Clinch River Nuclear Site
NRC Docket No. 52-047

Subject: Submittal of Supplemental Information Related to the Exclusion Area Boundary and Population Distribution Around the Clinch River Nuclear Site in Support of the Early Site Permit Application

Supplemental Information Regarding the Exclusion Area Boundary and Population
Distribution Around the Clinch River Nuclear Site

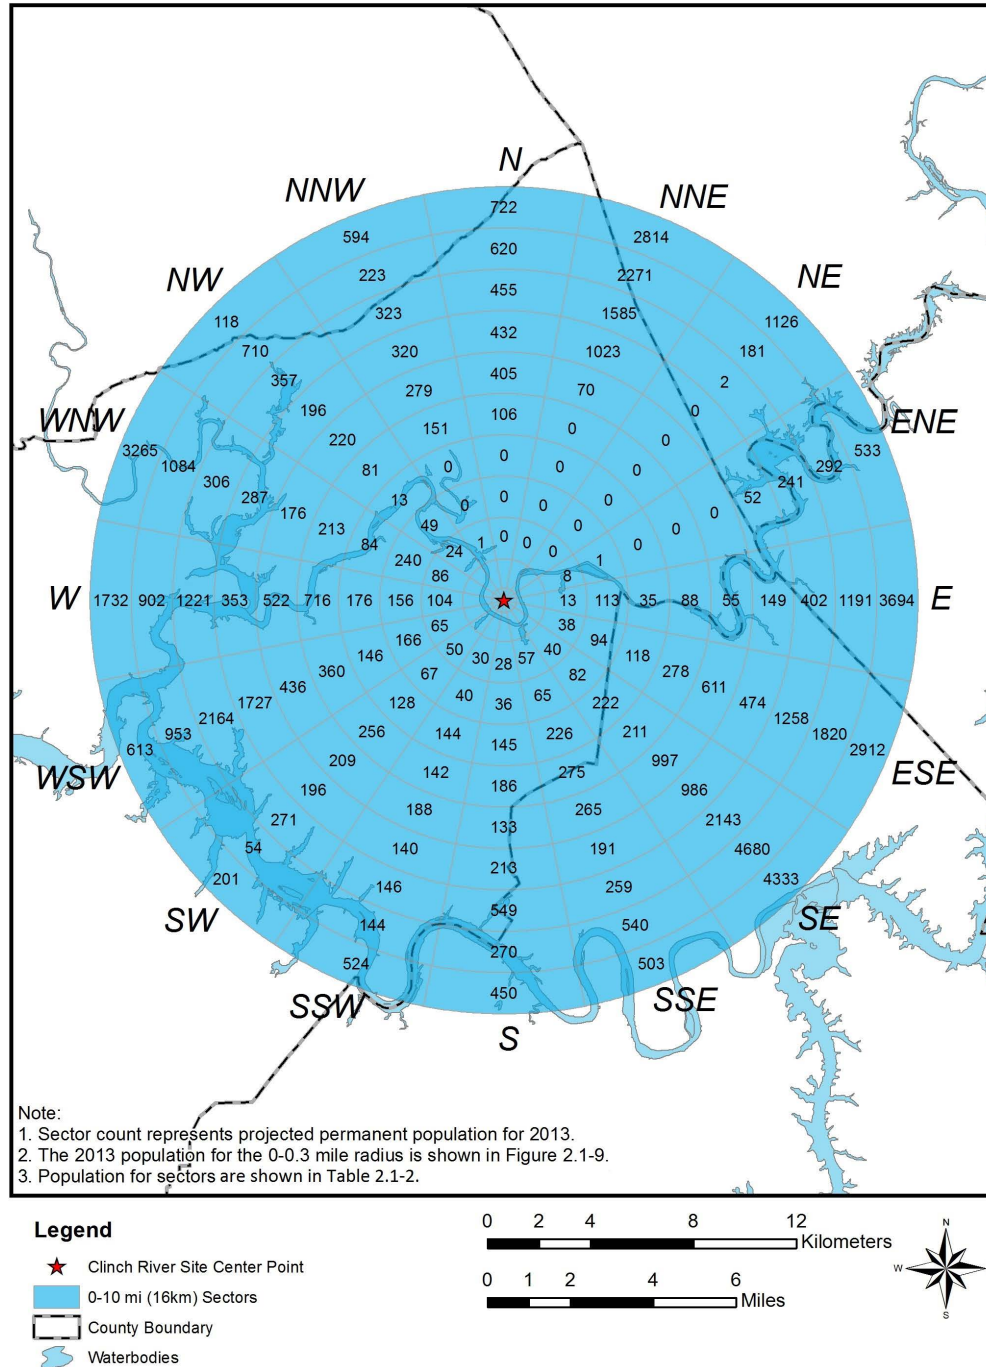
During identification of the above changes, it was determined that the ESPA does not clearly describe that the EAB and the CRN Property boundary are the same as the owner controlled area boundary. Therefore, SSAR Subsections 2.1.1 and 2.1.2 (including Figure 2.1-5) are being revised to provide this clarification.

The exclusion area boundary (EAB) is delineated by the boundary of the CRN Property, as shown on Figure 2.1-5.

SSAR Figure 2.1-5 is being replaced with the figure below.

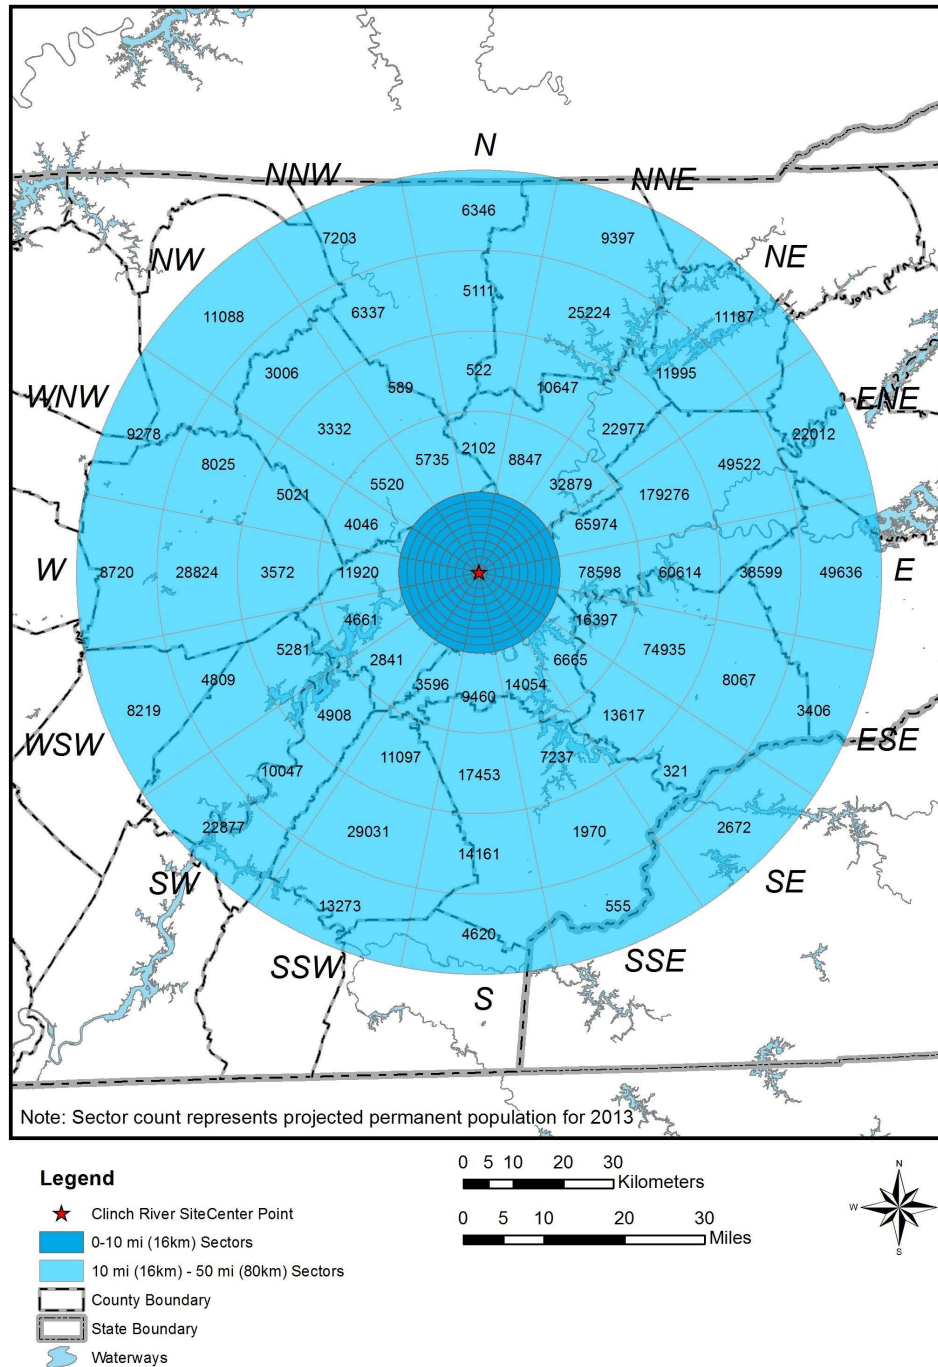
SSAR Figure 2.1-6 is being replaced with the figure below.

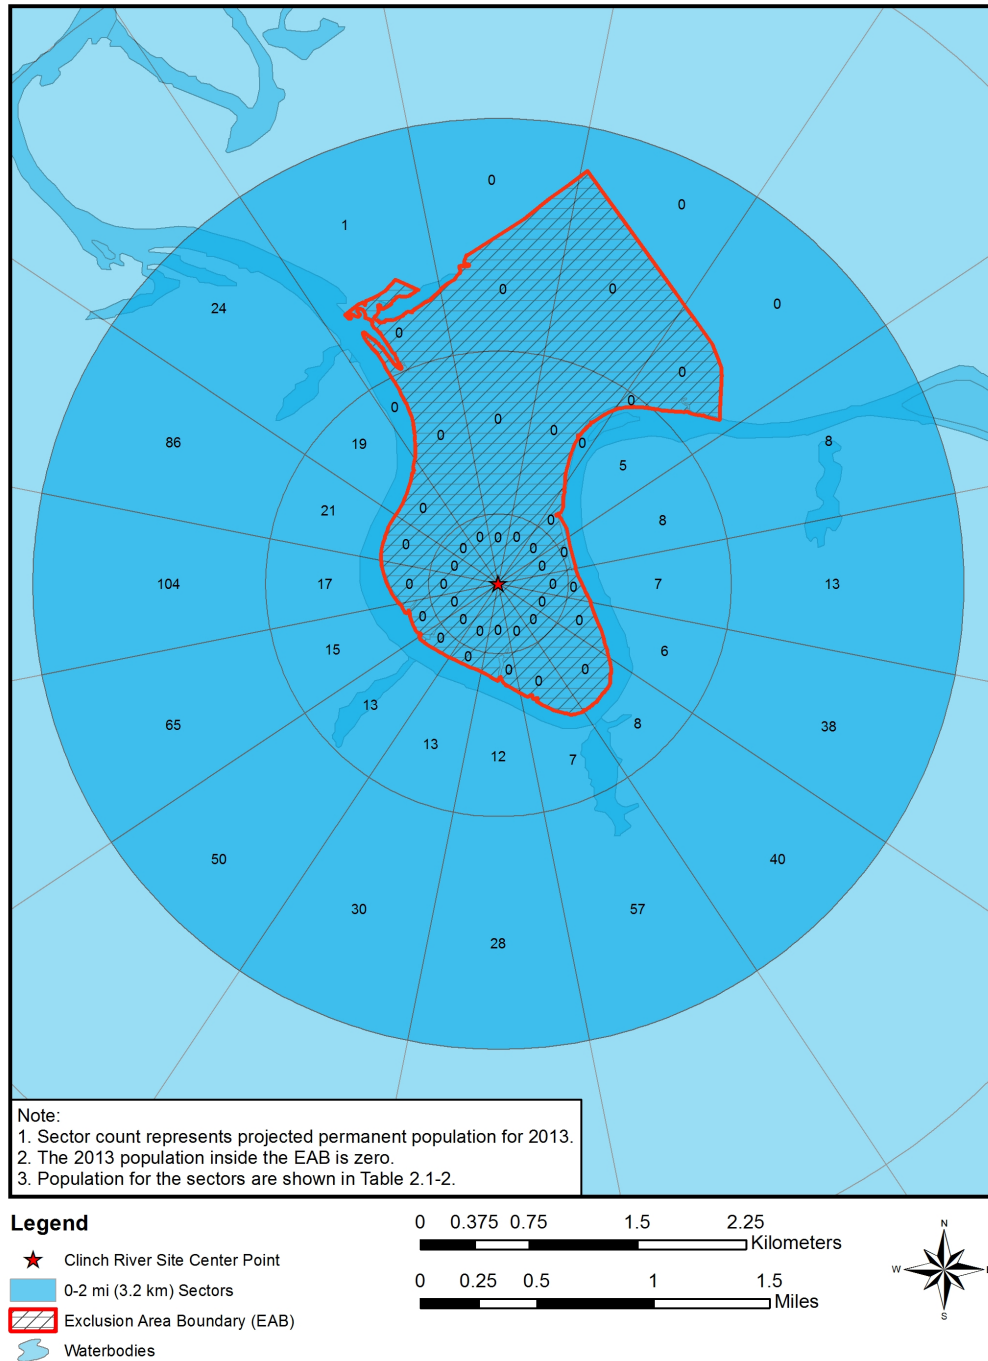
SSAR Figure 2.1-7 is being replaced with the figure below.

Figure 2.3.4-1. Effluent Release Boundary with Analytical EABs

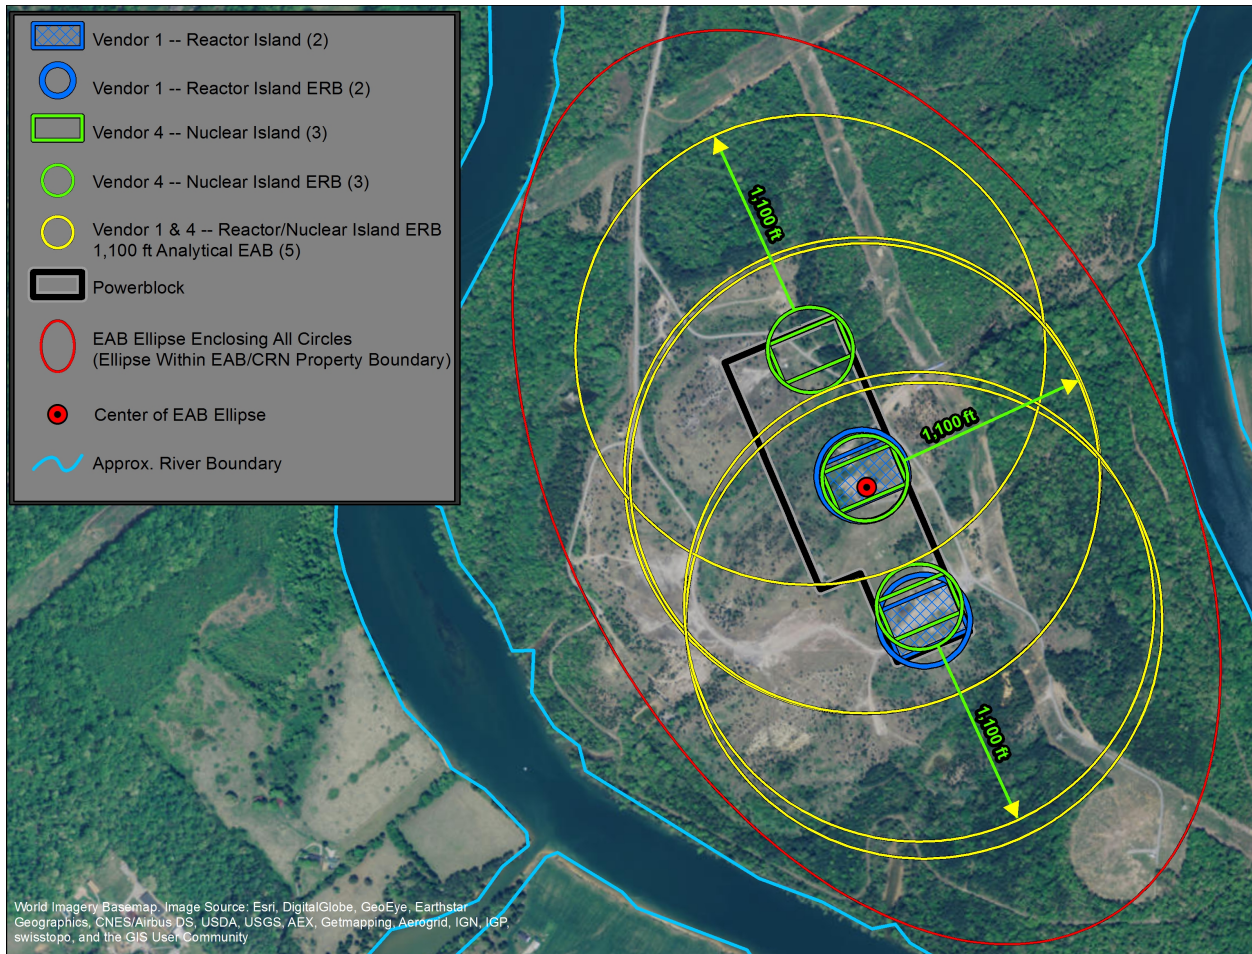
The site center point is determined as the centerline midpoint of the EAB ellipse (Figure 2.3.4-1). The ellipse has a short axis of 0.326 mi (524 m) from the site center point and long axis of 0.535 mi (864 m) from the center point.

SSAR Figure 2.3.4-1 is being replaced with the figure below.

Figure 2.3.4-2. Site Center Point and Distance to the LPZ

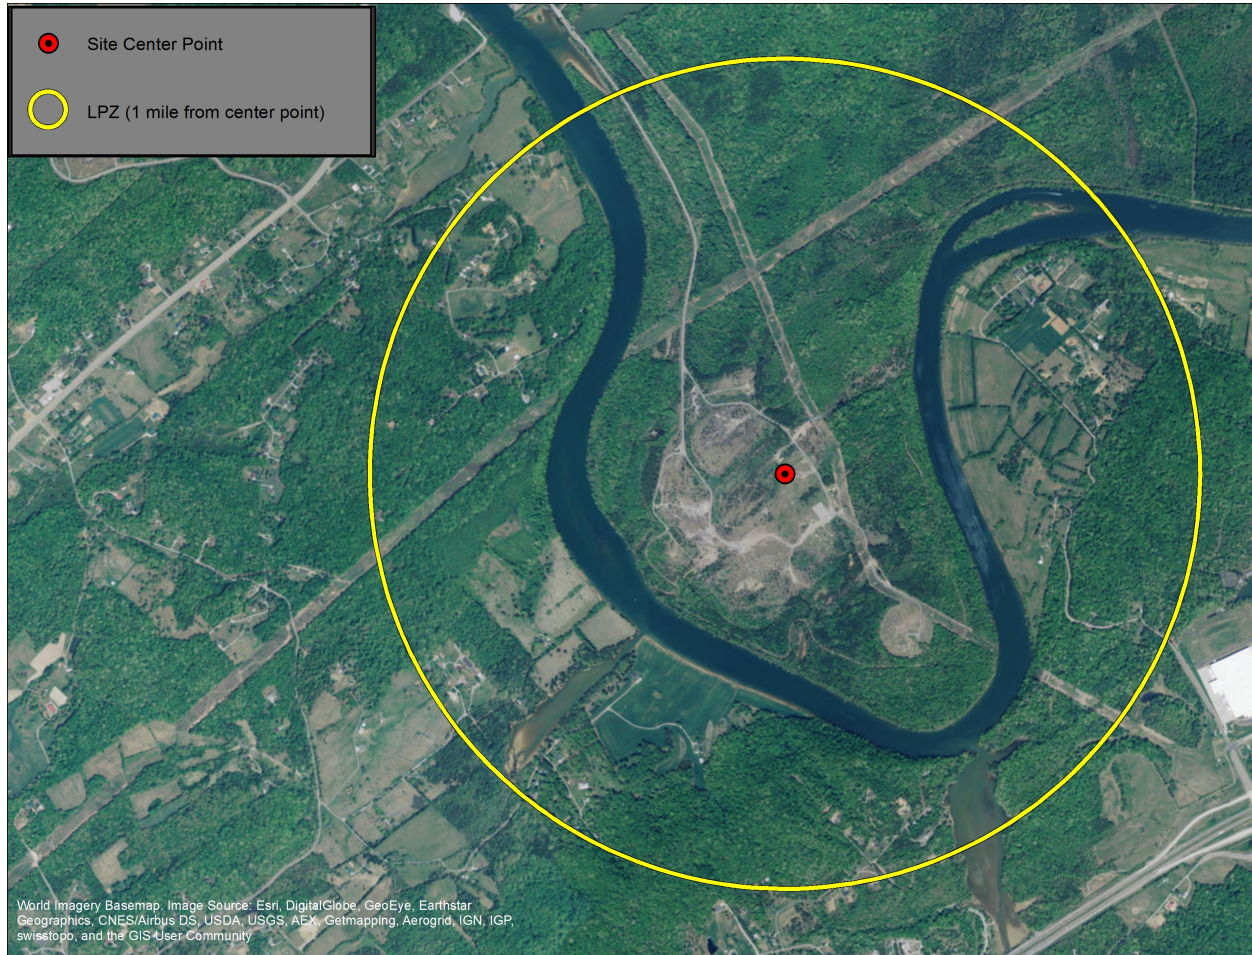
SSAR Figure 2.3.4-2 is being replaced with the figure below.

Figure 2.3.5-2. LPZ and Analytical EAB Distances Used for Terrain Analysis

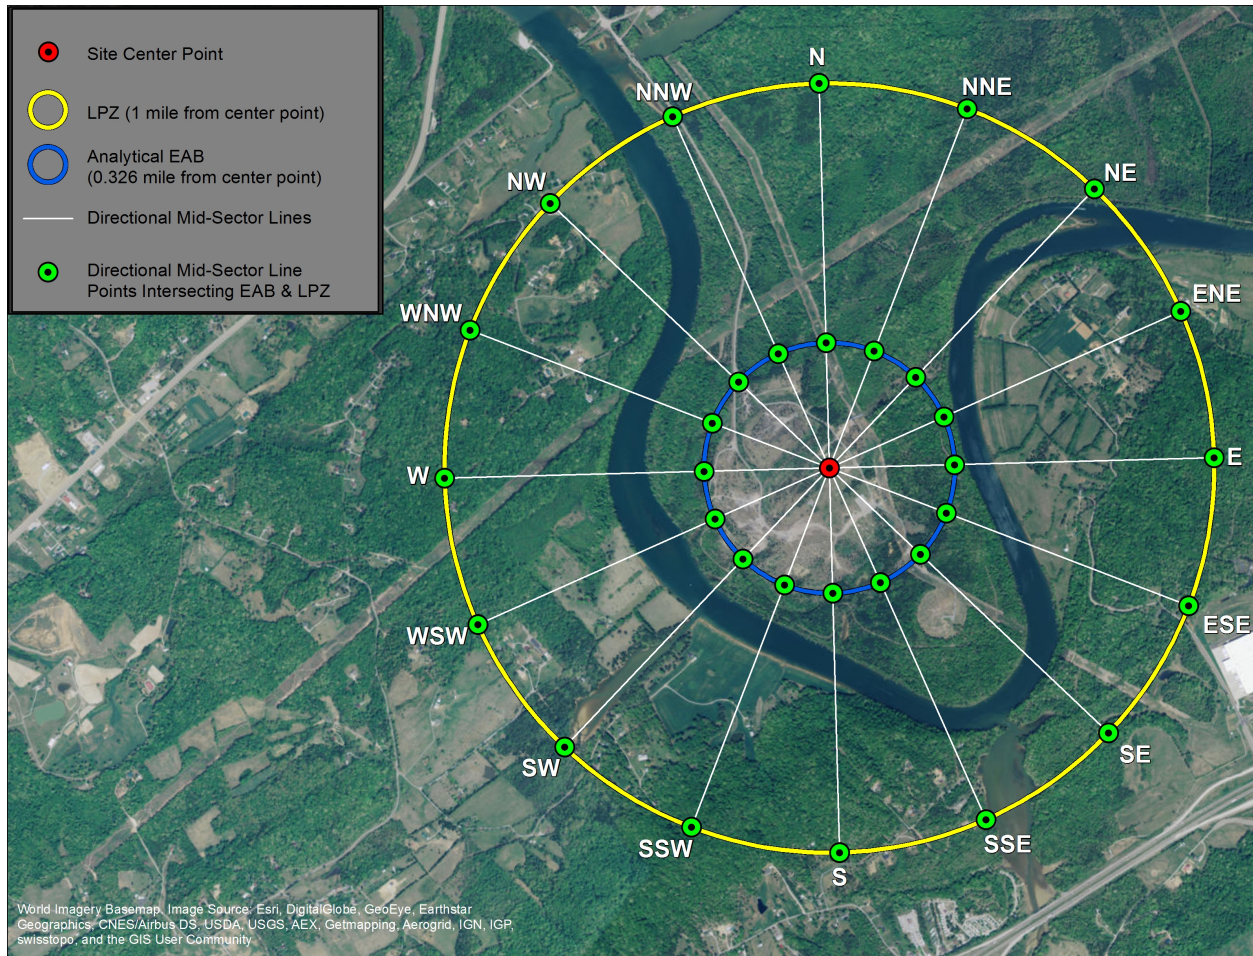
SSAR Figure 2.3.5-2 is being replaced with the figure below.

Figure 2.7.5-1. Effluent Release Boundary with Analytical EAB

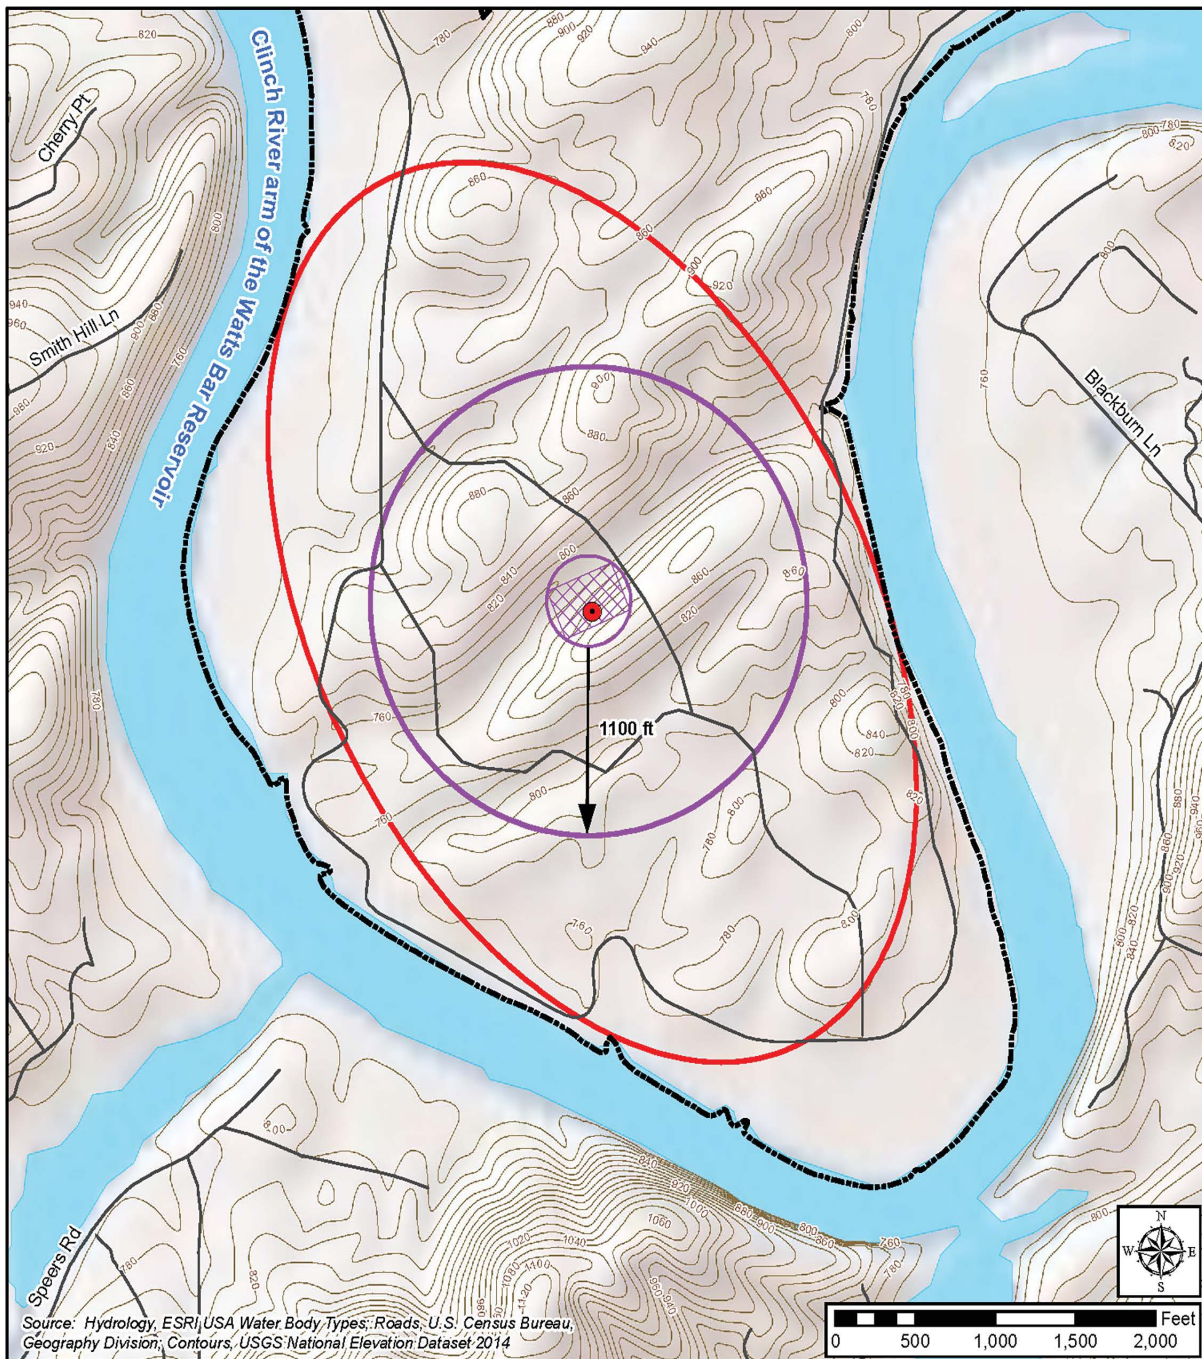
ER Figure 2.7.5-1 is being replaced with the figure below.

Figure 2.7.5-2. Effluent Release Boundaries (ERBs), Analytical EAB, and Site EAB

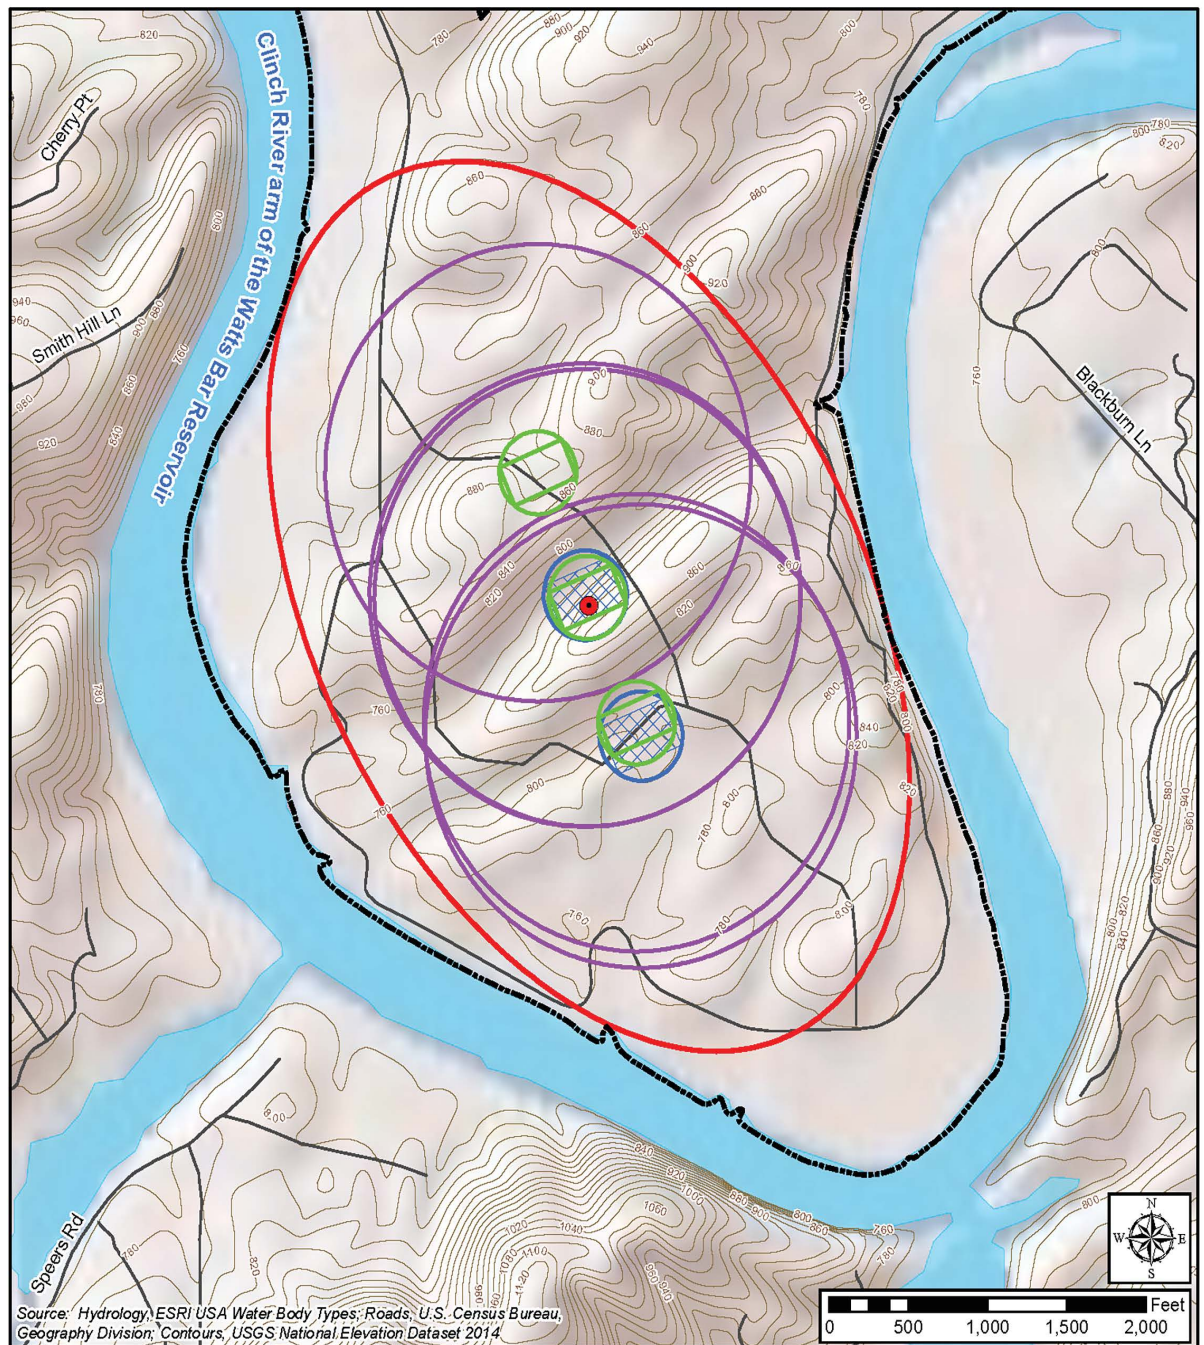
To account for multiple units on site, nuclear islands are positioned at multiple locations within the power block with associated ERBs and EABs as shown in Figure 2.7.5-2 (note that although the nuclear islands for vendors 1 and 4 are depicted in the figure, the nuclear islands, associated ERBs, and analytical EABs for vendors 1, 2, 3, and 4 fit within the EAB ellipse). The analytical EABs can be encompassed by an ellipse fixed completely within the CRN Property boundary, i.e. the actual EAB (Figure 2.7.5-2), which demonstrates that dispersion factor computations are conservative.

ER Figure 2.7.5-2 is being replaced with the figure below.
